HISTORIC AND DESIGN REVIEW COMMISSION

HDRC CASE NO: 2021-324
ADDRESS: 909 N HACKBERRY ST
LEGAL DESCRIPTION: NCB 529 BLK 2 LOT N 92.5 FT OF 13 & 14
ZONING: IDZ-1, H
CITY COUNCIL DIST.: 2
DISTRICT: Dignowity Hill Historic District
APPLICANT: Michael Garansuay/GARANSUAY MICHAEL S & TERESA P
OWNER: Michael Garansuay/GARANSUAY MICHAEL S & TERESA P
TYPE OF WORK: New construction of two, 2-story residential structures and two, 1-story residential structures
APPLICATION RECEIVED: June 30, 2021
60-DAY REVIEW: Not applicable due to City Council Emergency Orders
CASE MANAGER: Edward Hall
REQUEST:

The applicant is requesting a Certificate of Appropriateness for approval to construct two, 2-story residential structures and two, 1-story residential structures on the vacant lot at 909 N Hackberry, located within the Dignowity Hill Historic District.

E2 BUILDING A ELEVATION, SOUTH
1/4" = 1'-0"

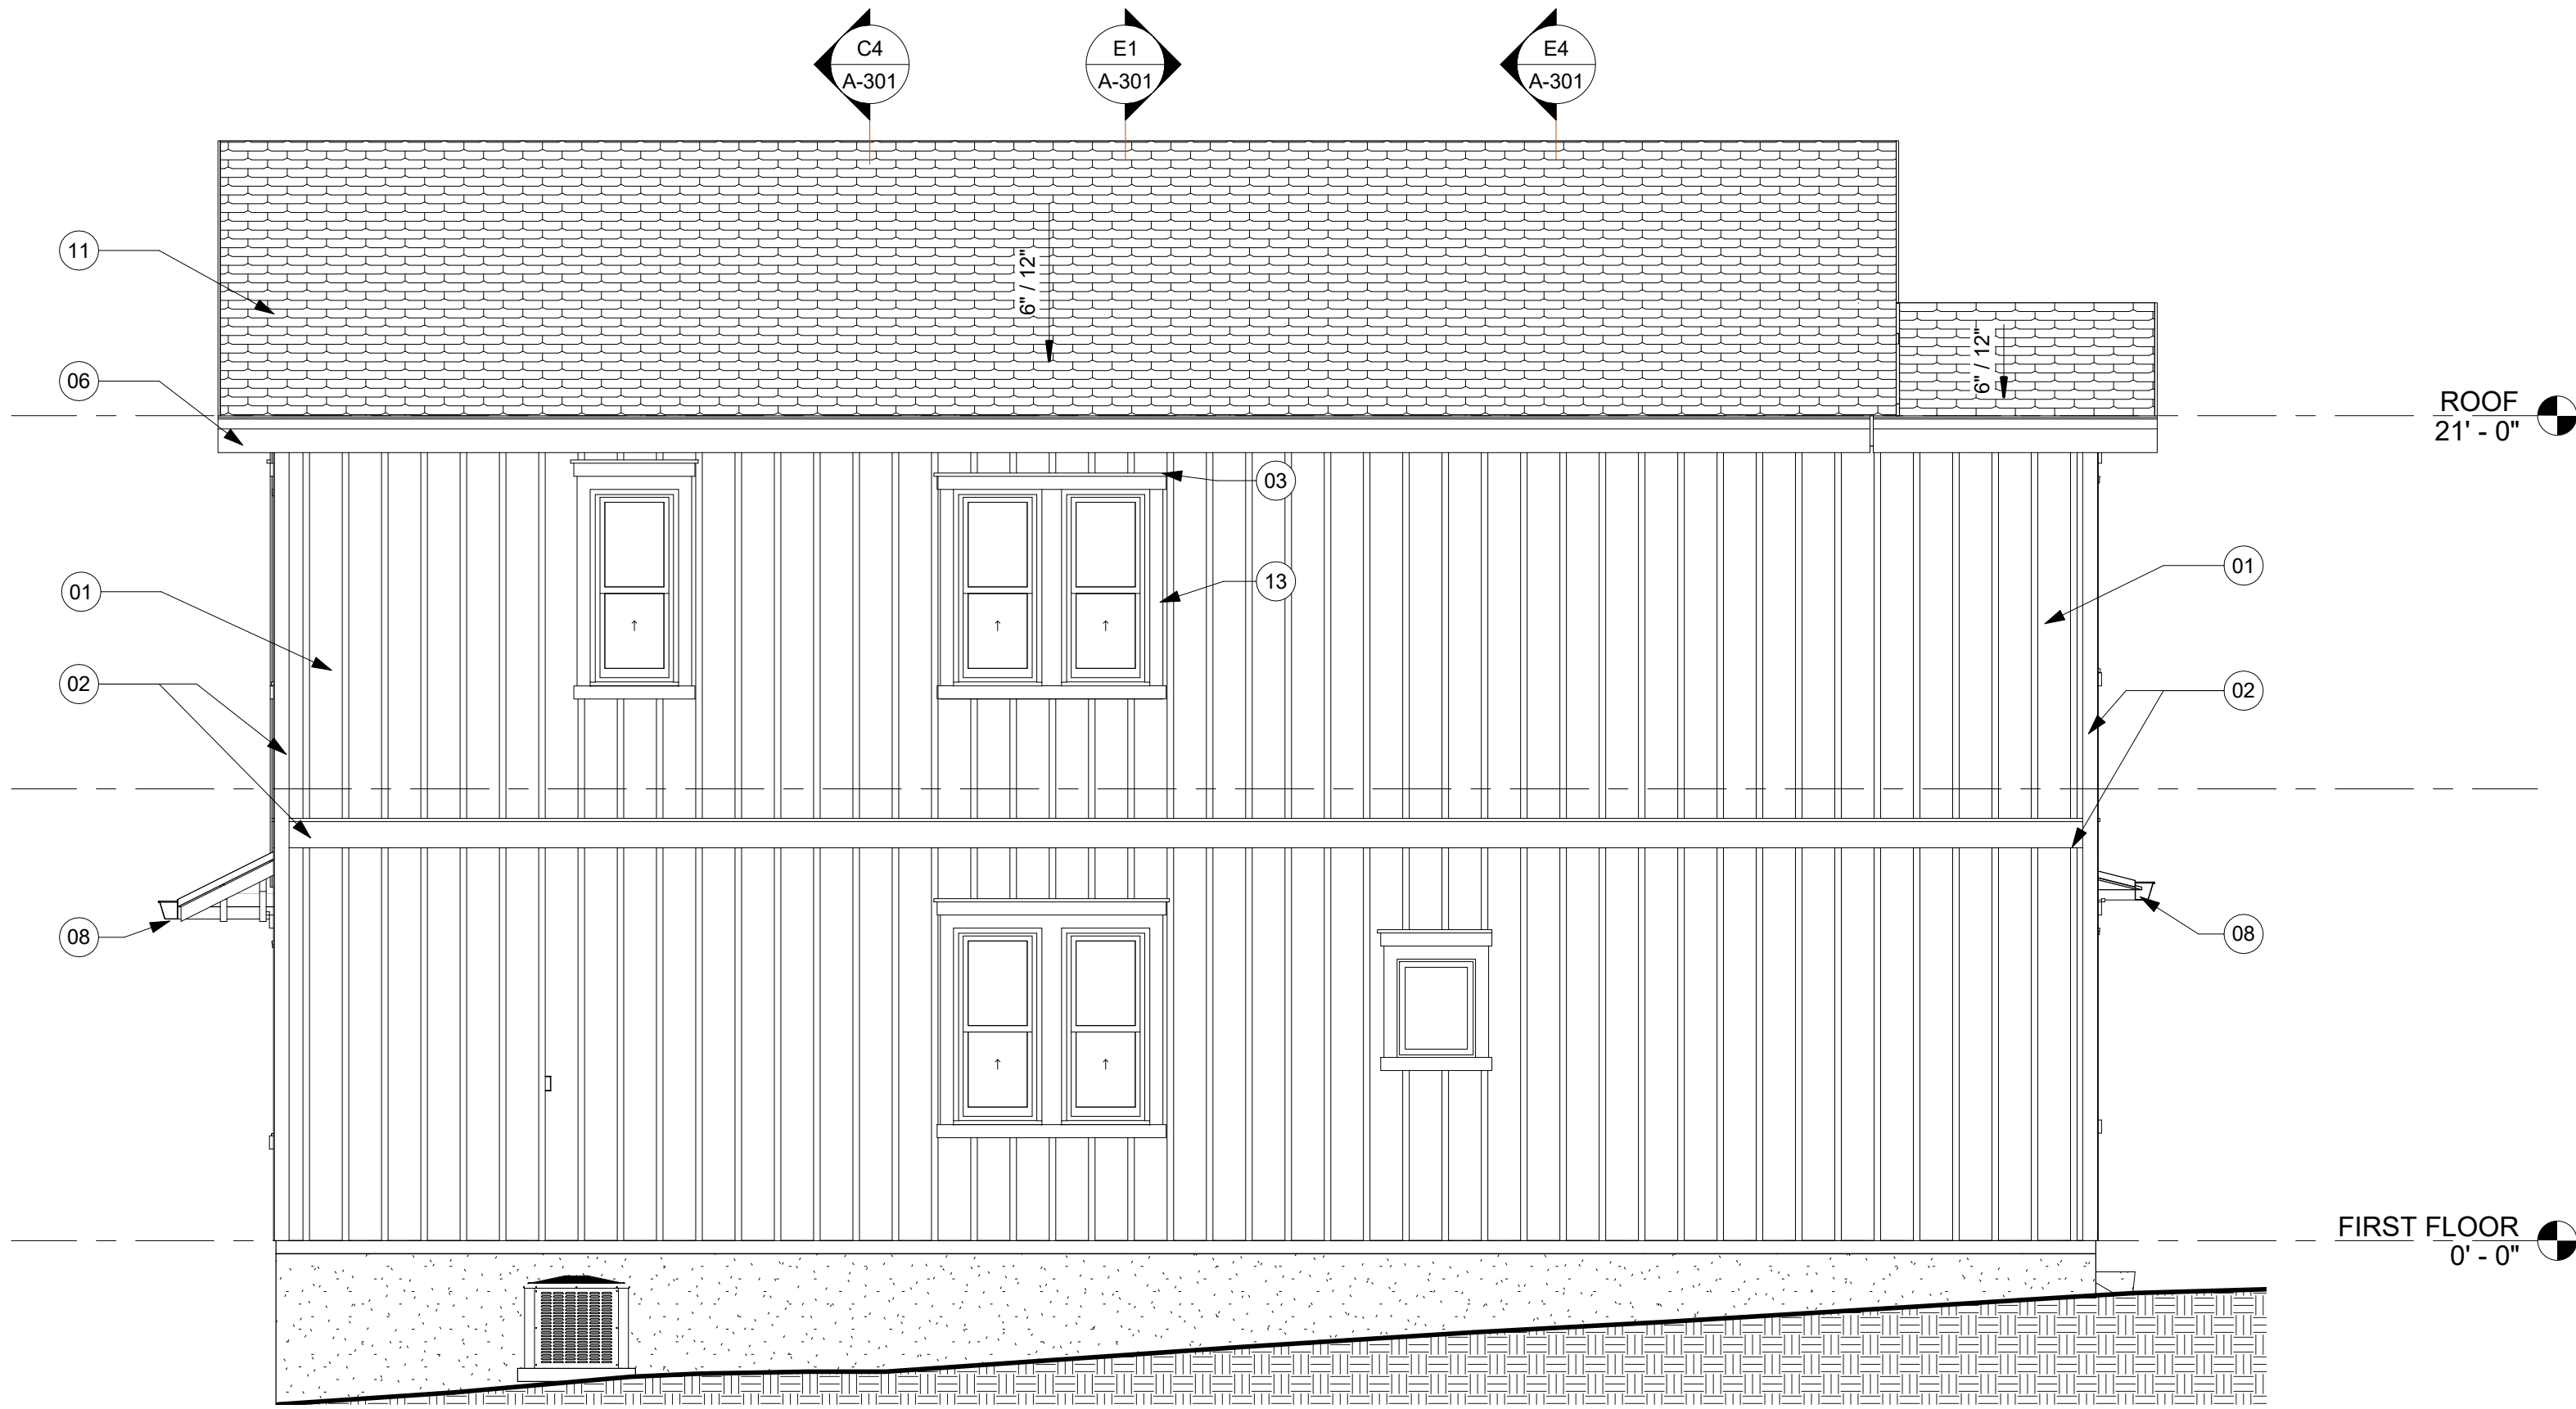
- j. **WINDOW & DOOR OPENINGS** – Per the Guidelines for New Construction 2.C.i., window and door openings with similar proportions of wall to window space as typical with nearby historic facades should be incorporated into new construction. Generally, staff finds the proposed window openings to be atypical in size with those found historically within the district. Staff finds that window groupings, heights, and widths should be modified to be consistent with those found historically within the district. As proposed, windows appear to feature widths and overall heights that are smaller in size as those found historically within the district. Additionally, staff finds that façade locations that are void of fenestration should be modified to feature window openings, specifically the south elevation of building A.
